Subject: Chamber Construction Manual

I updated the chamber construction manual (to version 1.1).

1) [image001.gif](#), downloaded 1803 times

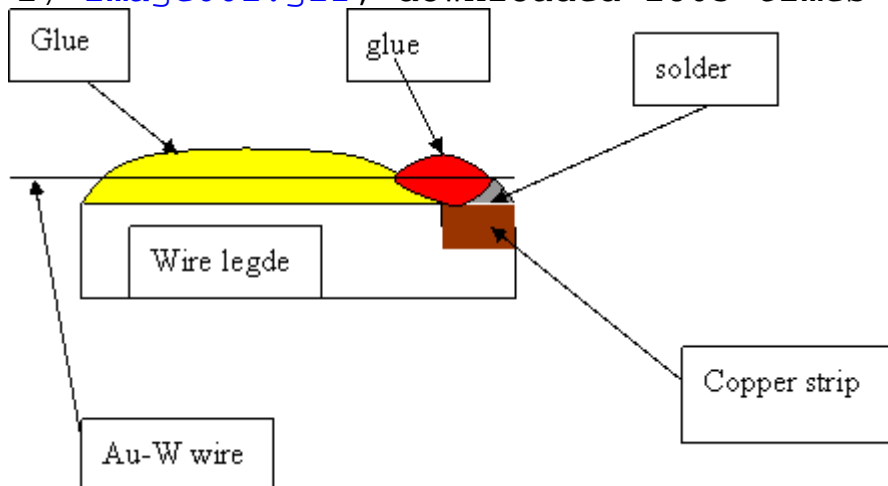
2. An suggestion: Oleg suggests to put some glue to between the glue which holds the anode wire on the wire ledge and the copper strip where the wire is soldered (see attached picture by Oleg).

This should prevent the breaking of the anode wire that we experienced at Heidelberg (see previous messages).

"after soldering of anode wires we put glue (red color) to fix the wire, solder and copper

strip together. It is need to remember that we have to safe a clean place on the copper strip to solder HV cable."

We also had this idea and did it on some chambers, but after discussion with Joerg at GSI, who never had any similar problem we thought that probably sanding the wire ledge edges is good enough and will solve the problem.

Another problem was that we wanted the glue to be cured before we cut the wires, and then we loose 1 day. This is probably not so critical, since at least in Heidelberg and Dubna where not too many people are involved in cahmber building one can find something else to do during this day.

So I would like to hear from GSI (Joerg) and Bukarest (Mihai) what they think. Since we have not put anodes on a chamber since a while due to technical difficulties with machiniery in our lab, I cannot tell at this moment what our experiences with sanding the wire ledges are. I will, therefore, not add this into the construction manual, until there are some more opinions about this additional step.
